VILLAGE OF LOMBARD
INTER-DEPARTMENTAL REVIEW GROUP REPORT

TO: Zoning Board of Appeals

HEARING DATE: March 24, 2004

ZBA 04-03: 310 W. Morris: The petitioner requests a variation from Section 155.406 (F)(2) of the Zoning Ordinance to reduce the corner side yard setback from twenty (20) feet to sixteen (16) feet to allow for the construction of an unenclosed, roofed over front porch.

Site Plan

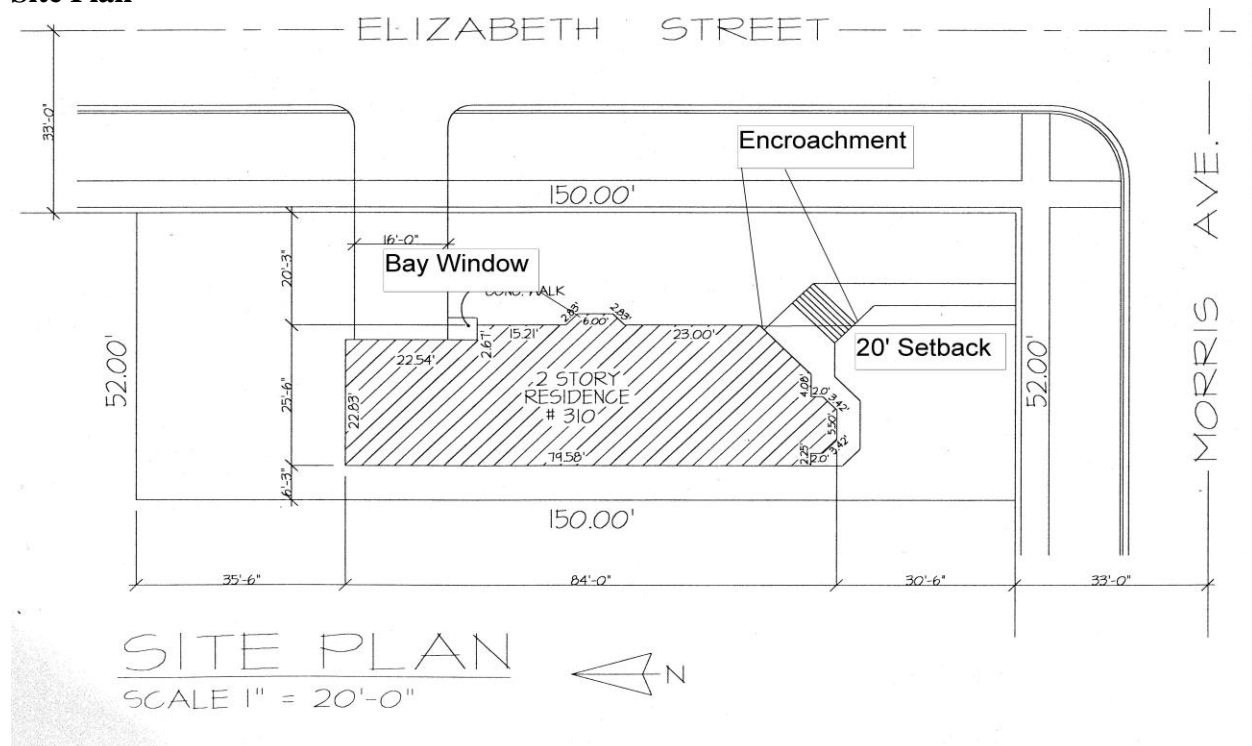
The petitioner plans to demolish the existing residence and construct a new house on the subject property. The petitioner presented the proposed building plans to staff for review. Staff informed the petitioner that the proposed roofed over, wraparound porch would not be considered a permitted encroachment on the Elizabeth Street frontage, which is considered the corner side yard. The petitioner revised the plans to reflect the current elevations. The revised elevations show a portion of the porch and stairs encroaching approximately four feet (4') into the corner side yard.

Roofed over, unenclosed porches are allowed to encroach five feet (5') into front yards assuming that the porch projects no more than seven feet from the front wall of the house. Roofed-over porches are not permitted to encroach into corner side yards given that the corner side yard setback is twenty feet (20') whereas the front yard setback is thirty feet (30'). Permitting the five foot (5') encroachment within the corner side yard in essence reduces the side yard setback to fifteen feet (15'), placing structures much closer to the street than if they were in the front yard. Staff finds that the proposed porch can be constructed according to code by modifying the proposed roof pitch and removing its encroachment into the corner side yard. Therefore, staff is not supportive of the requested variation. Furthermore, to be granted a variation the petitioners must show that they have affirmed each of the "Standards for Variation". Staff finds that the following standards have not been affirmed:

1. *Because of the particular physical surroundings, shape, or topographical conditions of the specific property involved, a particular hardship to the owner would result as distinguished from a mere inconvenience, if the strict letter of the regulations were to be applied.* Staff finds that there are no physical or topographical conditions effecting the subject lot that prevent the proposed home and porch from meeting code. While the lot is fifty-two feet (52') wide, the home and accompanying porch can be constructed to code on the subject lot. Staff finds that the porch can meet code by shifting the orientation of the stairs and landing toward Morris Avenue.

Steps four feet or less above grade which are necessary for access to a permitted building – The steps are a permitted encroachment, however the roofed-over porch is not.

Based on the submitted petition and the testimony presented, the requested corner side yard setback variation **does not comply** with the Standards required for a variation by the Lombard Zoning Ordinance; and, therefore, I move that the Zoning Board of Appeals recommend to the Corporate Authorities **denial** of ZBA 04-03.
